Re: Compliance Inspection
AFIN: 04-01732, State Permit No.: 4998-WG-CW (Expired)

NO DISCHARGE INDUSTRIAL PERMIT INSPECTION FORM

Re: AFIN 04-01732, Permit Tracking No. 4998-WG-CW (Expired)
Response to Inspection

Location:	FedEx Ground-Lowell Truck Wash				
Photographer:	Alison West		Witness:	None	
Photo #	1	Of	1	Date:	2/5/2013
Time:	3:49 p.m.				
Description:	September, 2012 Springdale Water Utilities invoice to FedEx. Invoice documents that the facility is on city sewer.

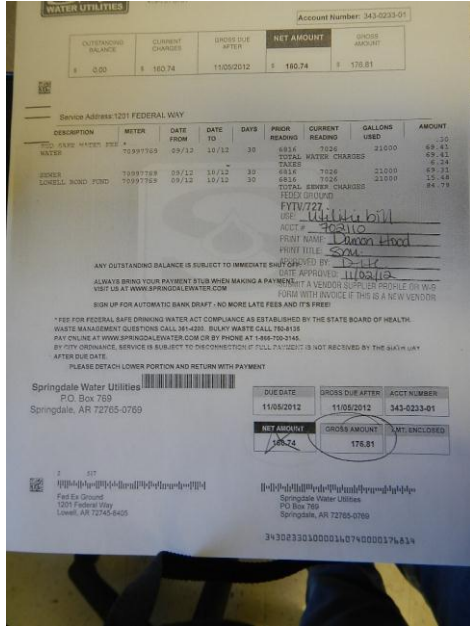
1. According to Lennia Daulton, FedEx employee, the septic system is no longer in operation. Ms. Daulton believed that the facility connected to sewer possibly around June, 2012. Ms. Daulton provided an invoice from the City of Springdale documenting the facility is connected to sewer. Please see photograph 1of 1. The above referenced No-Discharge Permit expired on October 31, 2012. The facility has not submitted the proper documentation to terminate the permit as required by the general permit. The following must be submitted to the Department:
